**Application for Permission Under Section 16 of the Town Planning Ordinance (Cap. 131) for Proposed Temporary Educational Institution (Teaching Farm) and Associated Excavation of Land for a Period of Three Years at Various Lots in D.D. 16, Wo Tong Pui, Tai Po, New Territories
(Planning Application No. A/NE-LT/794)**

Submission of Further Information

Responses-to-Comments table

Figure 3.3 Schematic diagram of Deodorization System

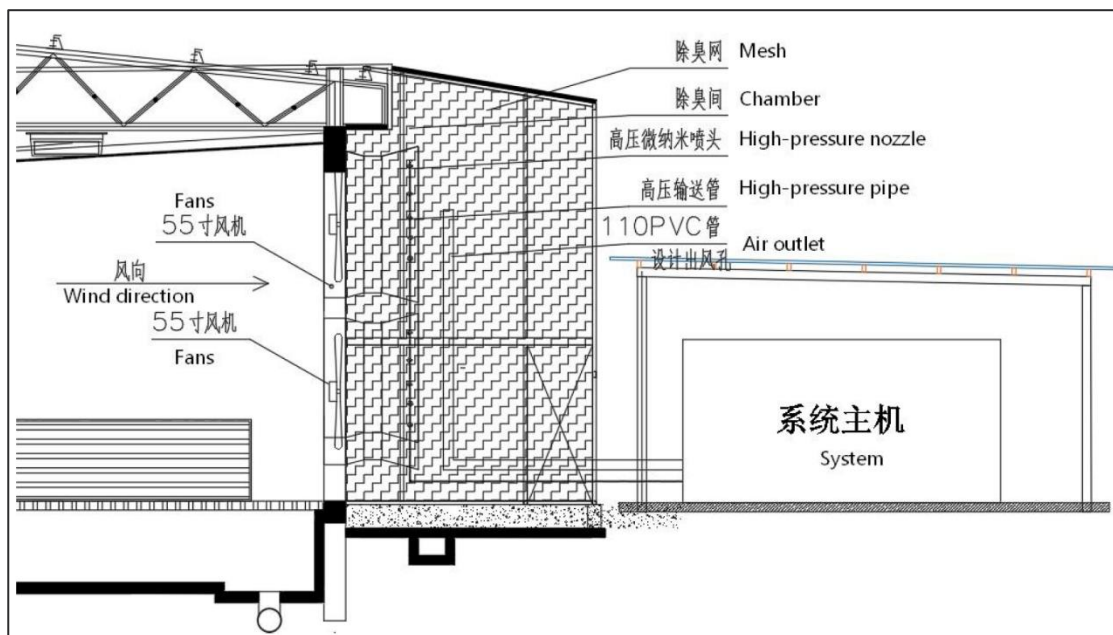
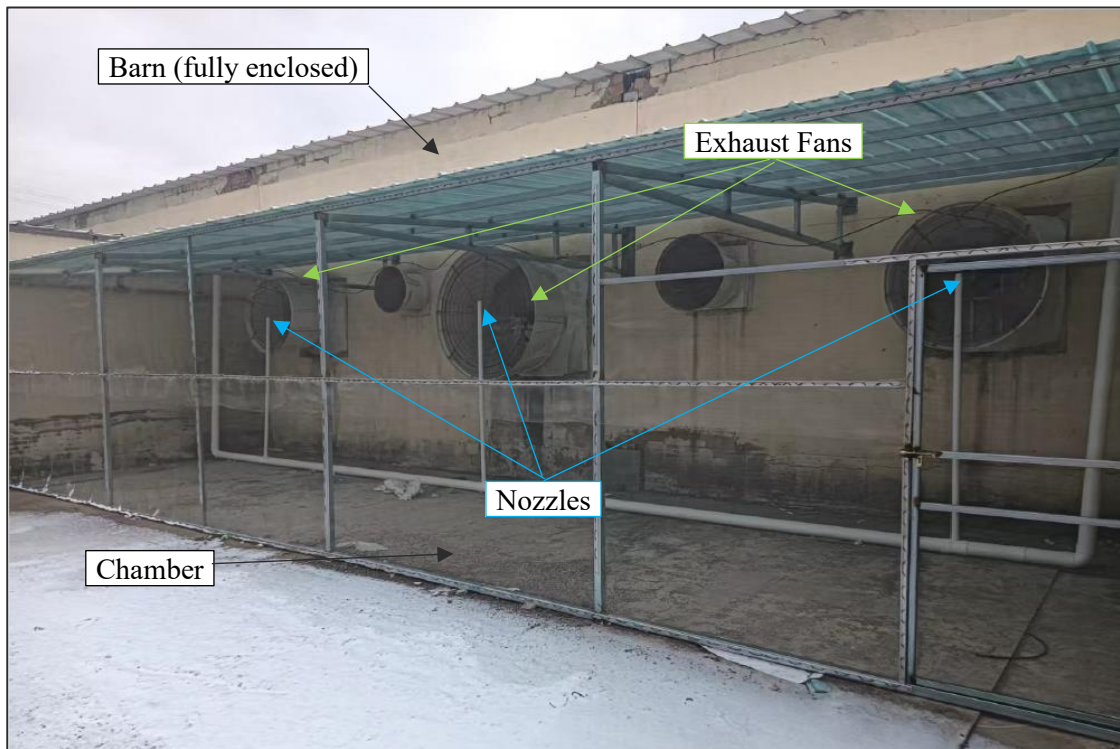
No.	Comments	Responses
	10. Section 3.5.4: Please explain why the odour impact from an uncovered overground sewage holding tank would be negligible. 11. Section 3.5.11: Please clarify whether the micro-nano deodourisation system is represented by Block 14 in Figure 2.2. 12. Please supplement the responses to our previous comment and update the report accordingly: Please check with regional office of EPD to see if there are any odour complaints against the existing Farm 1.0 in recent years. Please clarify whether odour patrol has been conducted to confirm the odour from the existing facilities.	composite moving-bed biofilm reactor are all housed within the unit and fully enclosed by the watertight cover of the pre-treatment facility. As such, no adverse odour impact is anticipated from the operation of the animal wastewater pre-treatment system. It should be "underground sewage holding tank" and refers to the existing arrangement at Farm 1.0. Under the proposed Farm 2.0 development, domestic sewage will be discharged directly to the public sewerage system and, therefore, any associated odour emission is expected to be negligible. The micro-nano deodourisation system is a new facility to be installed in Block 15. During the operation of Farm 1.0, odour mitigation measures included ventilation systems fitted with activated carbon filters and the application of biochar produced at EcoPark in Tuen Mun. However, disruptions to the biochar supply in 2024 and 2025 coincided with the receipt of odour complaints. After the biochar supply resumed, CityUHK Farm increased the application rate of biochar to the floor areas, particularly during wet weather. Good housekeeping practices were also implemented, including operator collection of manure and storage in underground manure scrape pits with stainless steel covers. These measures were effective in preventing odour, and no further complaints were received thereafter. The farm operator kept continuing to review the effectiveness of the existing odour control measures to minimize potential odour impacts as far as practicable. There will be improvement in the odour emissions from the facilities after this Project, such as new deodorization system for the new barn, dry-wet system and public sewer collection will be adopted to reduce

- 3.5.12 A micro-nano deodorization system, as illustrated in the accompanying schematic diagram (see **Figures 3.3 and 3.4**), is proposed to the third barn under Farm 2.0 (Block 15 in **Figure 2.2**). The entire system is configured on the exhaust side of the exhaust fans,
